RE: Coal Valley Resources Inc. Robb Trend Project, Environmental Impact Assessment and Mine Permit Application under the *Coal Conservation Act* (“CCA”) and Environmental Protection & Enhancement Act (EPEA), ERCB Application 1725257, EPEA -028-00011066, Supplemental Information Requests

**Robb Trend Project
Environmental Impact Assessment and Mine Permit Application
EPEA - 028-00011066; ERCB - 1725257**

Supplemental Information Request Responses

Supplemental Information Request
 EPEA Application No. 028-00011066
 ERCB Application No.1725257
 Received: July 26, 2012; September 18, 2012

FIGURE: **17-1**

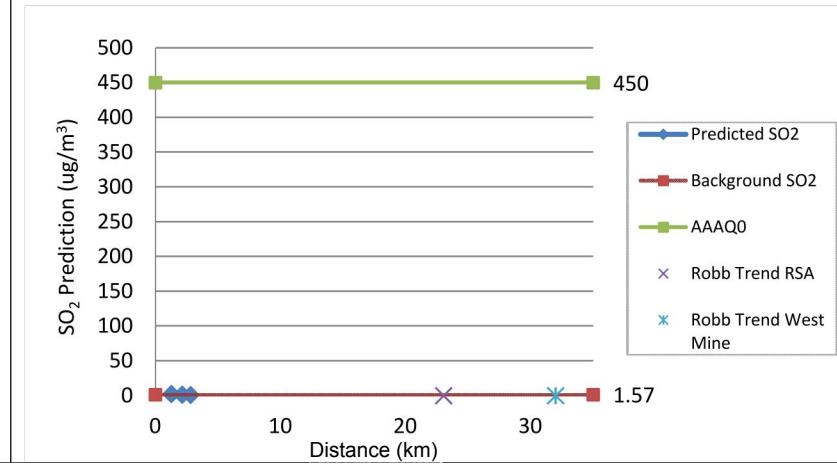
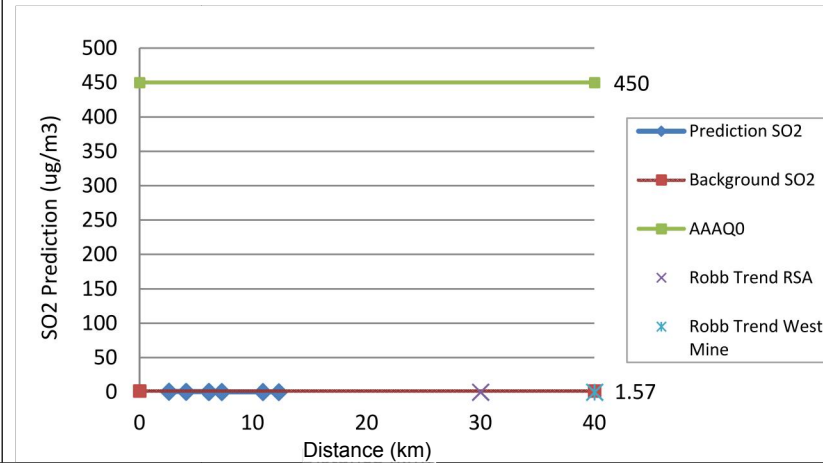
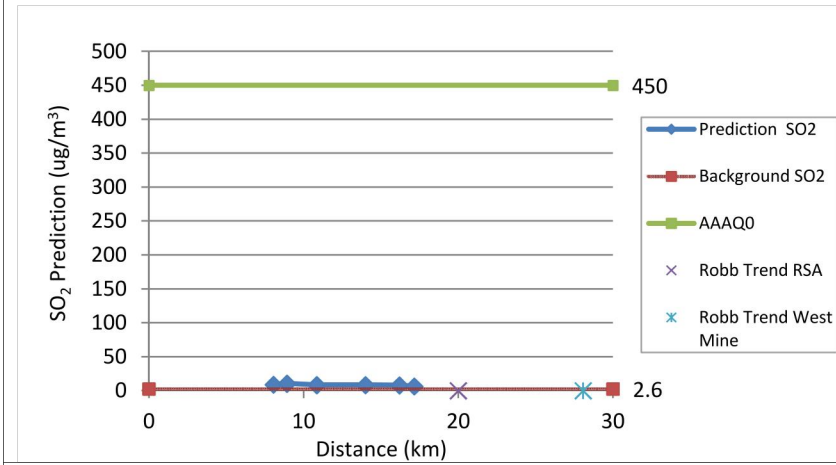
- Draw a line from the centre of this activity to the Project activity, which in this case was the community of Robb and the west pit operations. This is the path that plumes from these projects would follow to impact the Project (ESRD Figure 17-1).

ESRD Table 17-3 summarizes distances between the modelled Project and the major sources identified in ESRD SIR #17a). ESRD Figure 17-1 shows the locations of these sources and ESRD Figure 17-7 illustrates the location of existing and proposed facilities and WCAS monitoring stations within 100 km.

ESRD Figure 17-1 shows the relative locations of the nearest mining and quarry operations. ESRD Figure 17-2 to 17-6 show that predictions decrease with distance from the source. The approach taken to evaluating the impact of the nearest major mining operations (and the industry within their study areas) was to estimate their maximum impact on the edge of their respective study areas nearest the Project RSA boundary, and to superimpose this prediction onto the Project MPOI.

TITLE:
**SO₂ Predictions from Three Mines toward
the Robb Trend RSA Boundary and MPOI
Locations**

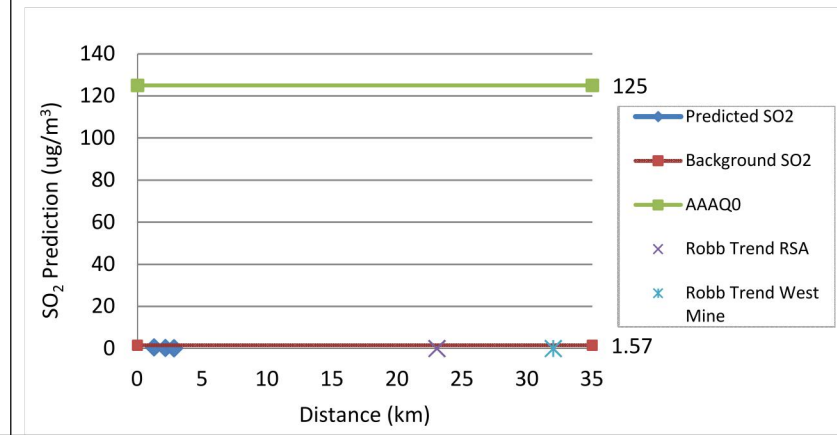
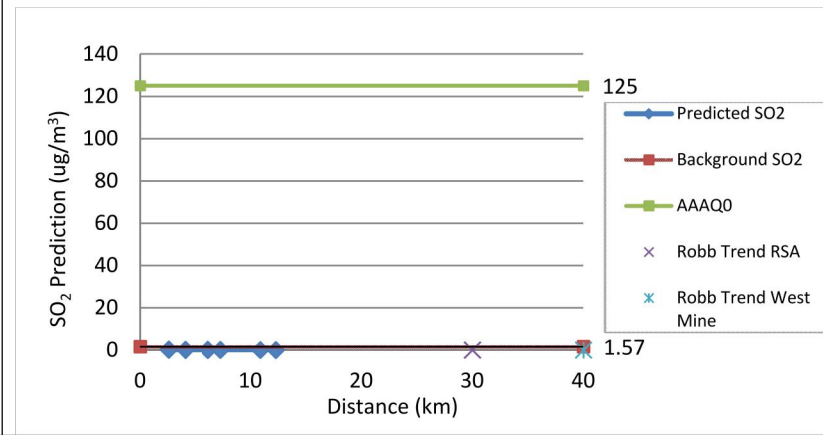
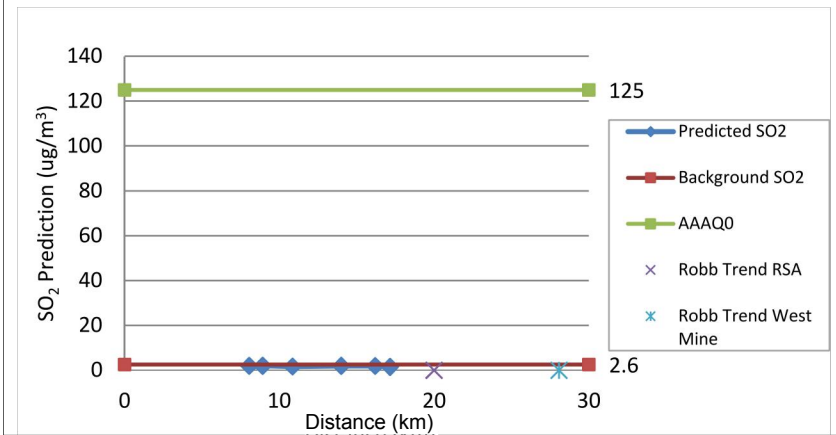
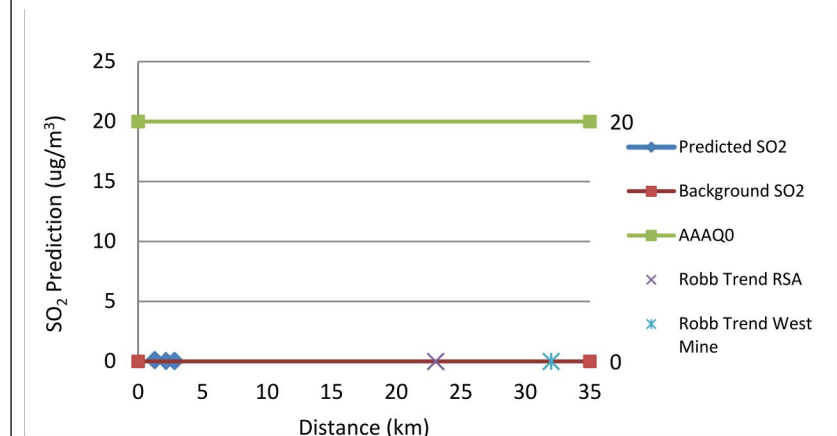
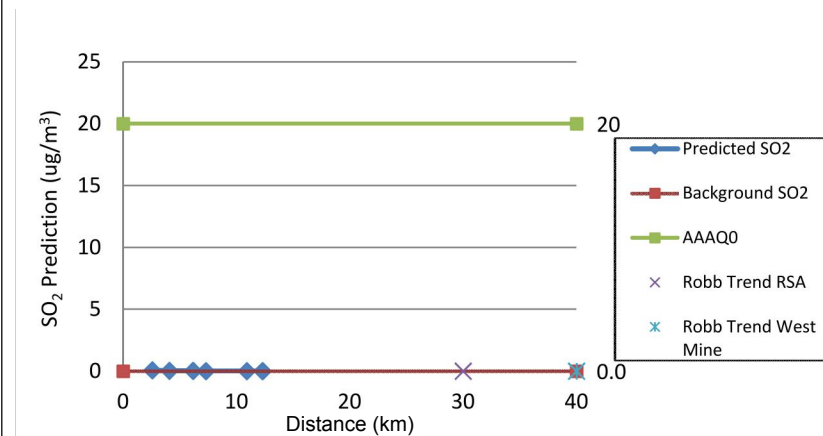
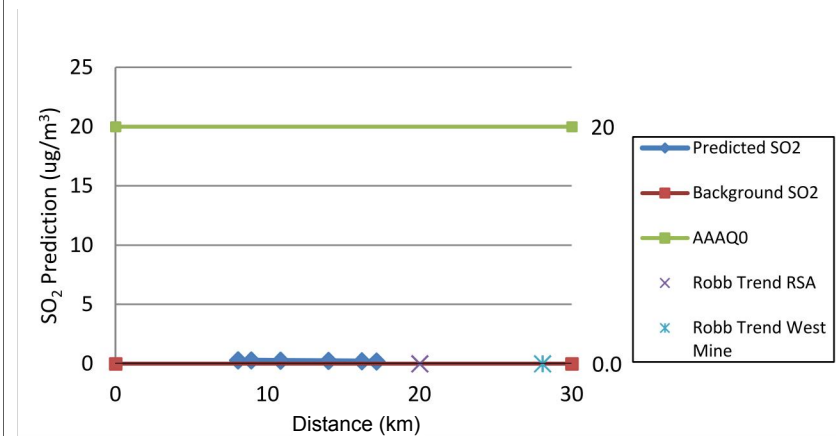
The results of the approach are shown in graphical form in ESRD Figures 17-2 to 17-6. Each graph shows the predicted fall-off of concentration with distance from the source, the background concentration used in the assessment (ESRD Table 17-1), and the applicable AAAQO. The graphs also show the distance from each project to the edge of the Project RSA and to the west pit near Robb.
